November 30, 2007
BEI Job No. 207055

**Subject: Addendum to Workplan
1630 Park Street
Alameda, California
Fuel Leak Case No. RO0000008**

LEGEND	GOOD CHEVROLET 1630 PARK ST. ALAMEDA, CA SOIL TPH AS GASOLINE ISOCONCENTRATION MAP 8.5-12.0 FT. BGS	FIGURE 2
	BEI JOB NO. 207055

Attachment: Figure 2: Soil TPH as Gasoline Isoconcentration Map; Revised

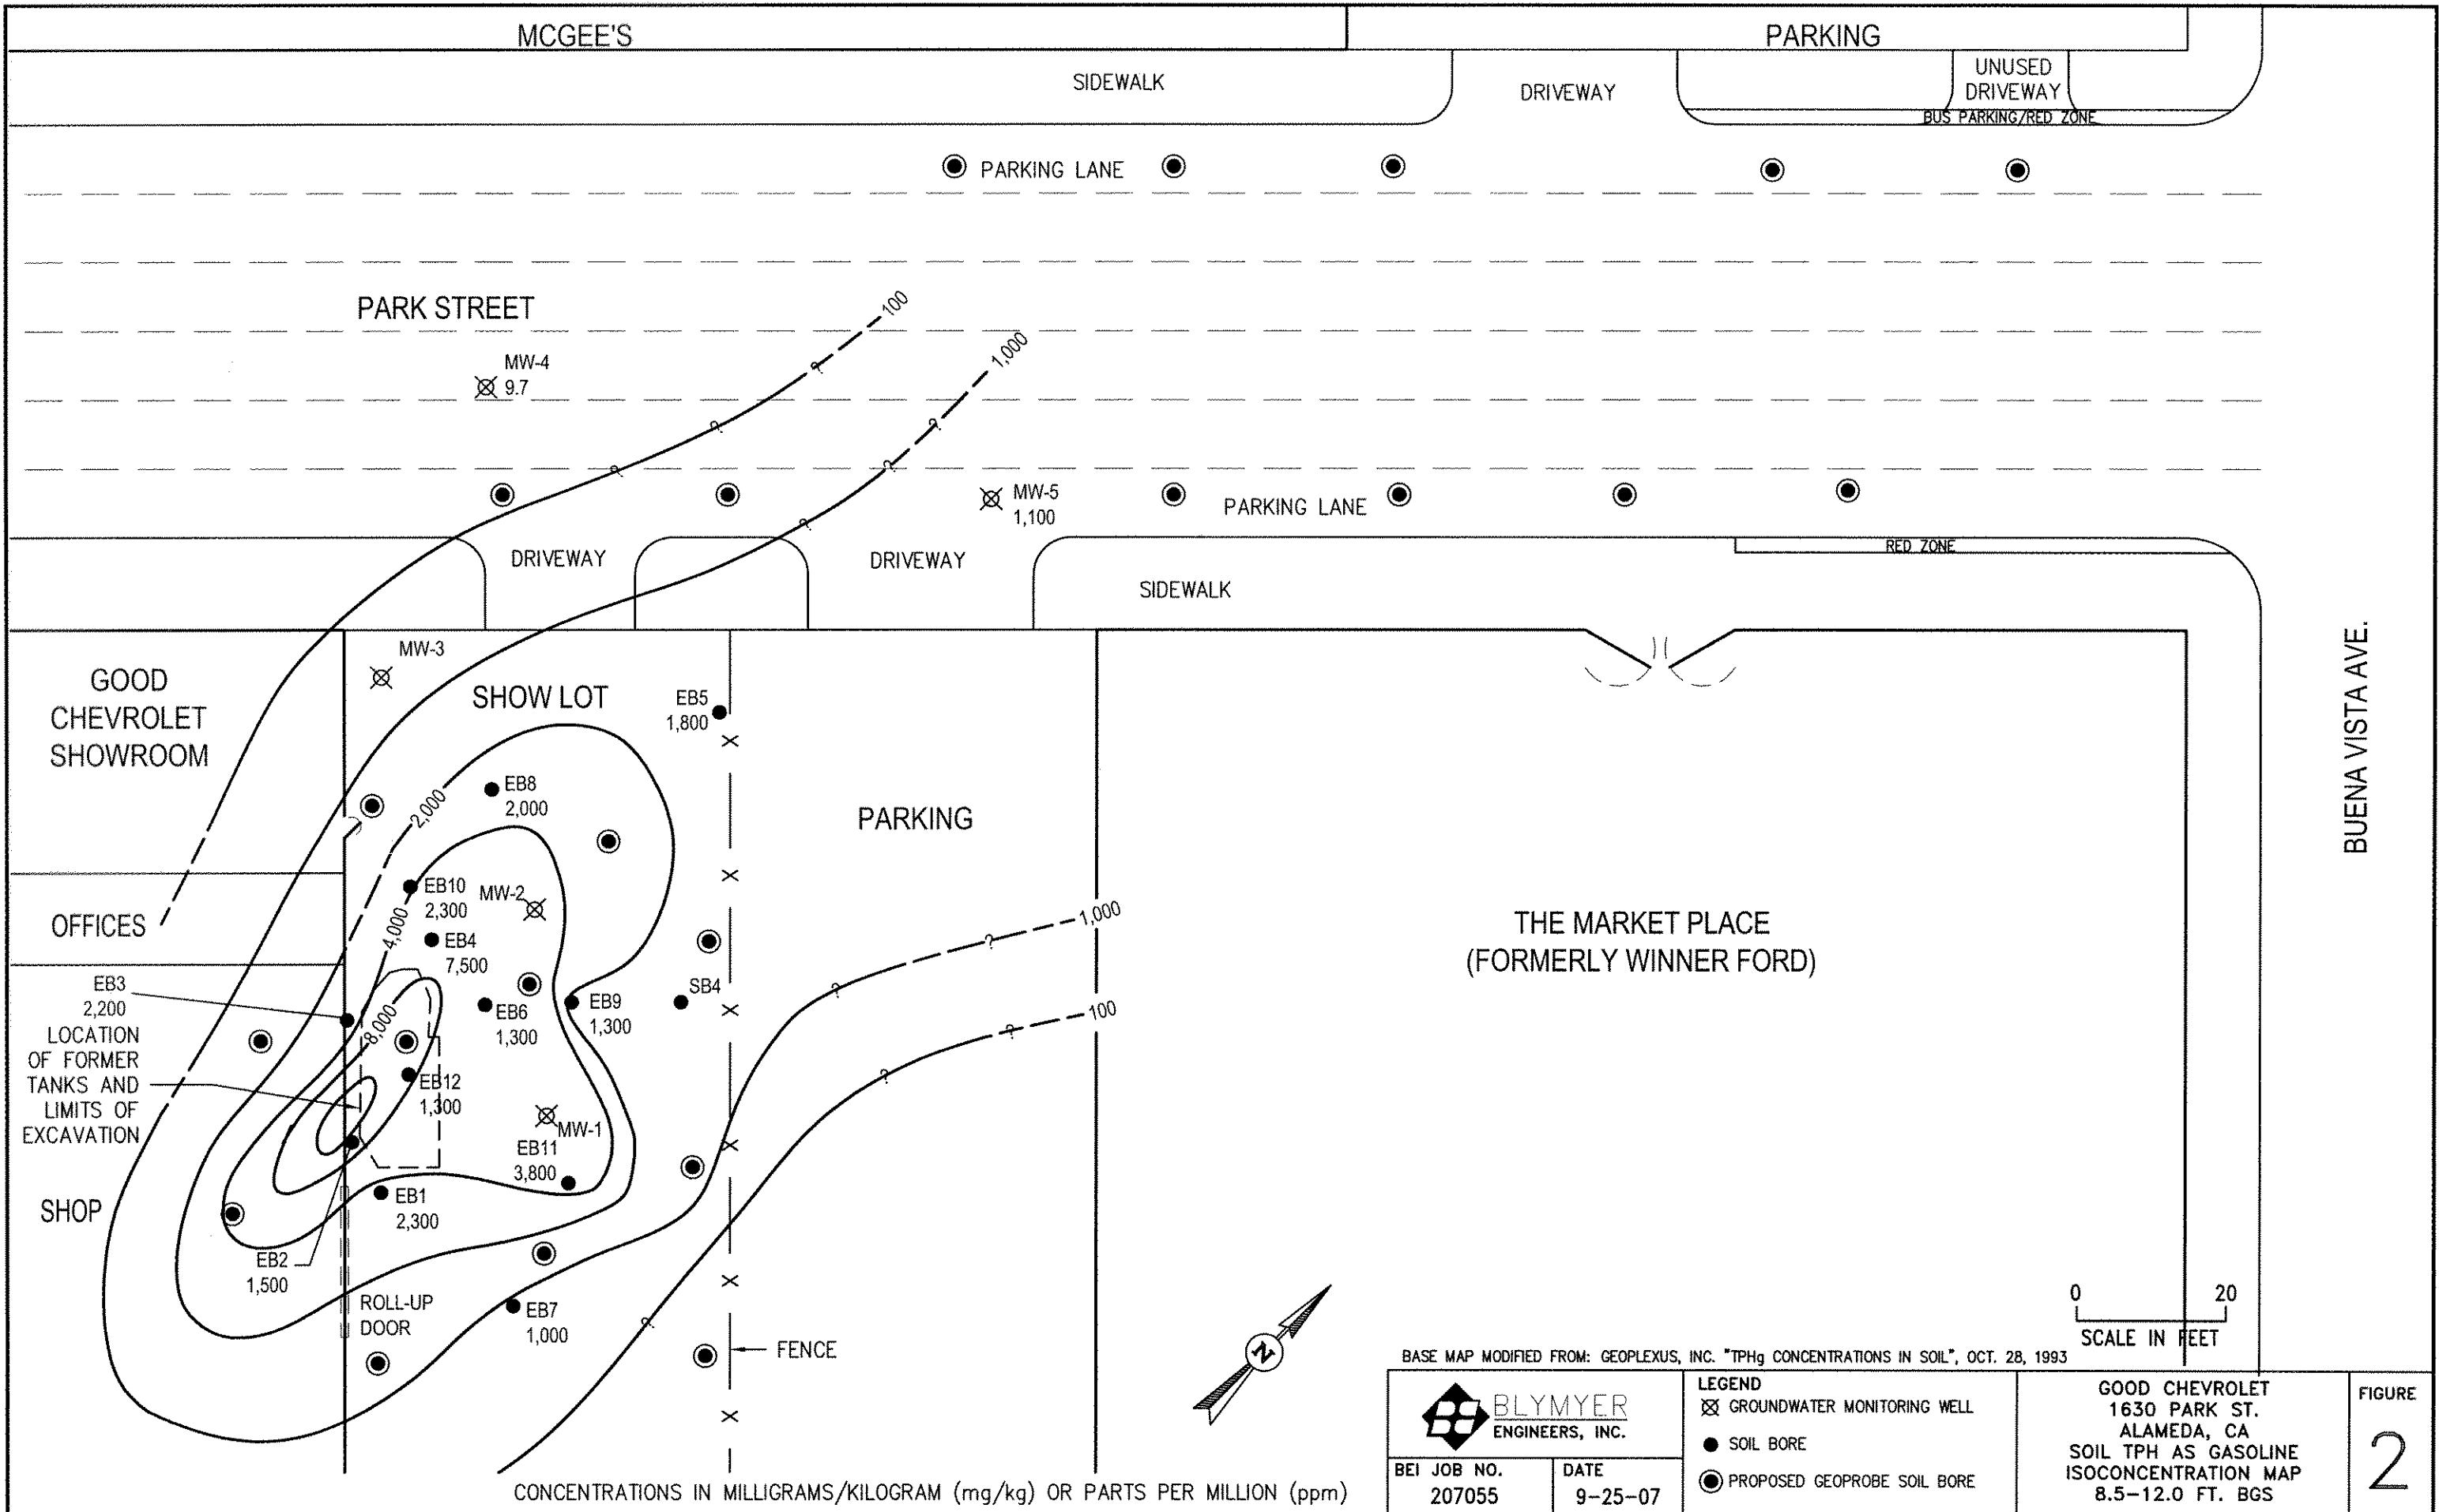
Comment 3a: Install multiple additional borings onsite, including a deep soil bore to 25 feet, to help delineate the extent of contamination at the point of release, and downgradient of the release onsite.

Comment 3b: Install multiple additional borings as transects on both sides of Park Street at 20- to 30-foot intervals (Blymyer Engineers has proposed at 30-foot intervals).

Based on the request for additional data at specific locations contained in the ACEH letter, Blymyer Engineers proposes to install an additional 14 to 16 Geoprobe soil bores at the approximate locations

depicted on Figure 2. These locations will help determine and refine the vertical and lateral extent of residual soil and groundwater contamination as it currently is distributed at the site and site vicinity. Towards that end, Blymyer Engineers proposes to:

- Install one 25-foot deep soil bore at the location of the former UST,
- Install seven additional onsite bores (for a total of 10), and
- Install six to seven additional offsite bores (for a total of approximately 11 to 12) in two parallel transects on both sides of Park Street.

This will entail retaining a Geoprobe drill rig for a total of three to four days. This will allow for the intelligent placement of a minimum of two wells upon review of the data generated, as clarified by the ACEH in the November 1, 2007 letter.

Blymyer Engineers proposes the temporarily removal of the soil bore on the adjacent property (The Market Place) in order to minimize potential conflicts and to allow use of the additional data to be generated such that any future intrusions on to the property can be minimized and any future bores can be intelligently placed on that parcel. Those potential bores can be installed at the time the required wells are installed.
